### — M.V. "DUNEDIN STAR" —

SKETCH SHOWING POSITION OF TWEEN DECK BMDs

NOW FITTED IN AFTER BODY OF SHIP.

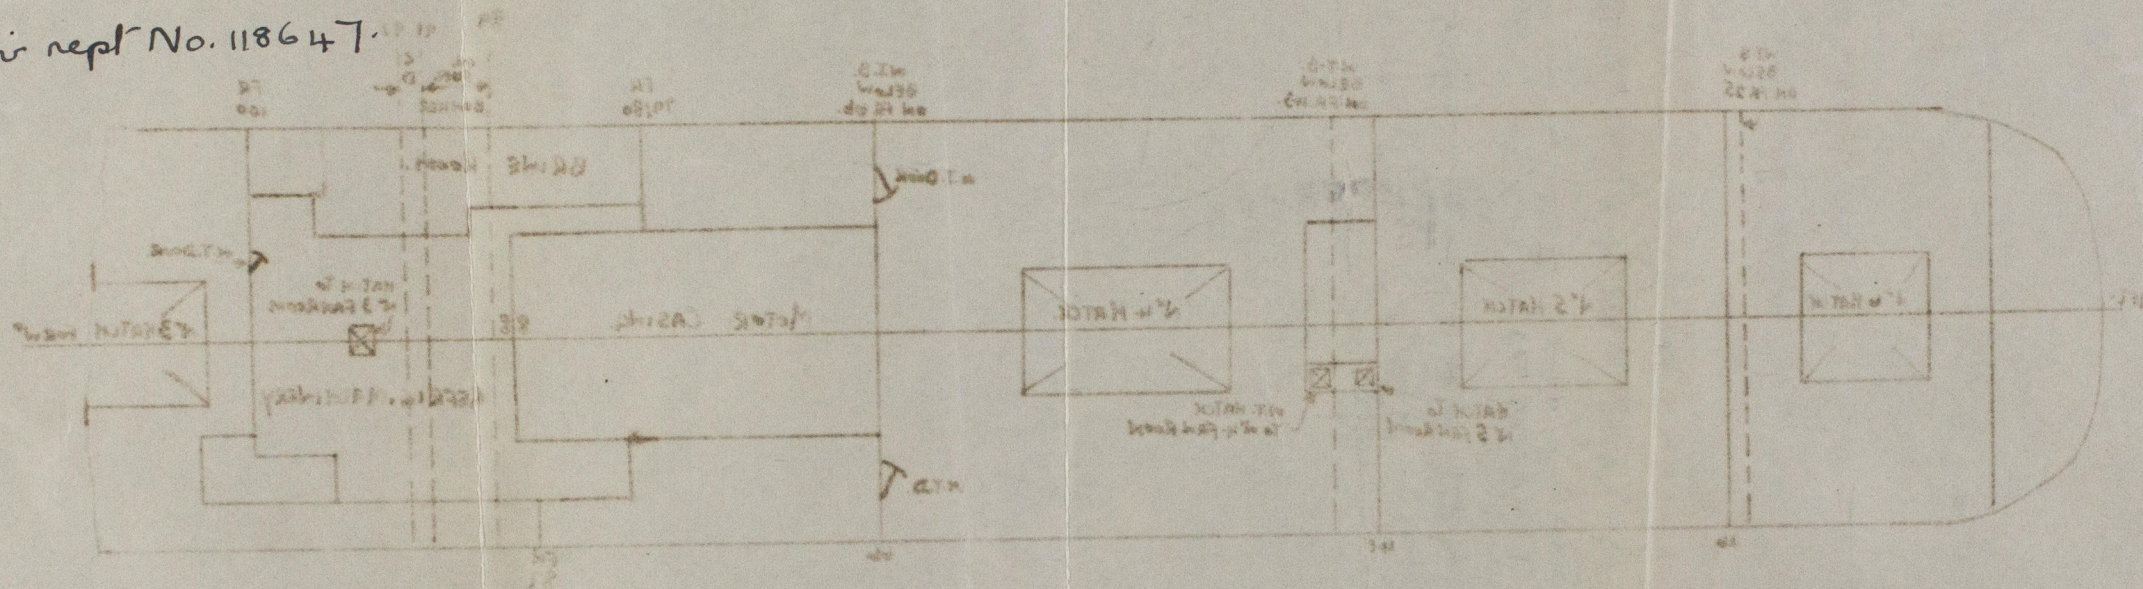
NOTE: — IT IS CONSIDERED THAT THE STEEL BMDs ORIGINALLY  
FITTED IN TWEEN DECKS IN FORE BODY OF SHIP AND  
AT PRESENT INSULATED ON BOTH SIDES MAY BE  
ACCEPTED WITHOUT BEING MODIFIED.

*access hatch  
to be fitted  
with w.t. coaming  
& cover*
